Approval no: DEV2016/813/6

03 March 2026
Ref. No. 21282

Re: Greenbank Shopping Centre – Stage 1 Upgrade

Figure 1: New Arch Layout change

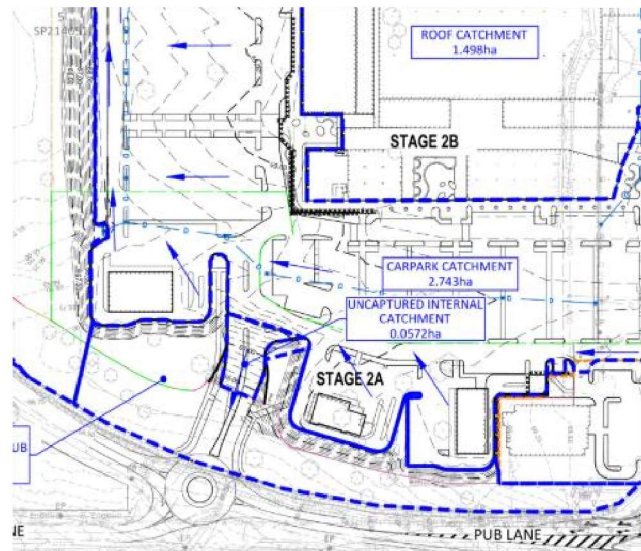
With the proposed architectural revised layout (SD 10003 – rev F) in the area shown in Figure 1, the stormwater overland flow (Figure 2) is directed west and north toward the basin, as indicated in the SWMP report.

Accordingly, the only amendment would be for the islands across the flow path to be constructed flush with the surrounding surface so as not to interfere with the overland stormwater flow paths. The islands may still incorporate bollards, trees, gravel, and other landscaping materials; however, they should not include any raised edges, barriers, or mounding that could obstruct flow.
